ECE/TRANS/WP.29/2010/43 18 December 2009

Consideration of draft amendments to existing Regulations

<u>Proposal for Supplement 3 to the original version of Regulation No. 125</u> (<u>Forward field of vision of drivers</u>)

Submitted by the Working Party on General Safety Provisions \*/

"Figure 7: Definition of the area "S" (paragraph 5.1.3.2.)

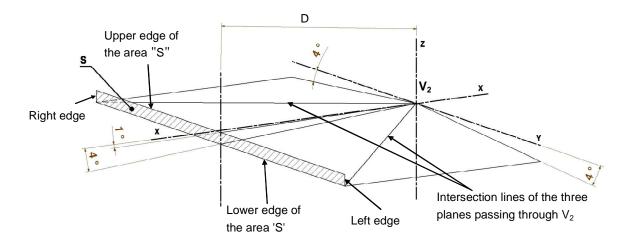
#### Insert a new paragraph 5.1.3.2., to read:

"5.1.3.2. An obstruction between a plane through  $V_2$ , and declined at least 1° below the horizontal and a plane through  $V_2$  and declined 4° below the horizontal will be tolerated if the conical projection of this obstruction, starting from  $V_2$ , on an area "S" as defined in paragraph 5.1.3.2.1. does not exceed 20 per cent of this area. The steering wheel, if adjustable, shall be placed in the normal position indicated by the manufacturer or, failing that, midway between the limits of its range(s) of adjustment."

#### Insert new paragraphs 5.1.3.2.1. and 5.1.3.2.2., to read:

- "5.1.3.2.1. The area "S" (see Annex 4, Appendix, figure 7) is a rectangular vertical area located in a plane perpendicular to the X coordinate 1,500 mm forward of the point V<sub>2</sub>. The upper edge of the area "S" is defined by a plane passing through V<sub>2</sub> declined forward 1° below the horizontal. The lower edge of the area "S" is defined by a plane passing through V<sub>2</sub> declined forward 4° below the horizontal. The left and right edges of the area "S" are vertical and generated from the intersection lines of the three planes declined 4° as defined in paragraph 5.1.2.2. above.
- 5.1.3.2.2. In the case of a windscreen extending beyond 1,500 mm forward of the point  $V_2$ , the distance between the area "S" and the point V2 may be extended accordingly."

### Annex 4, Appendix, insert a new figure 7, to read:
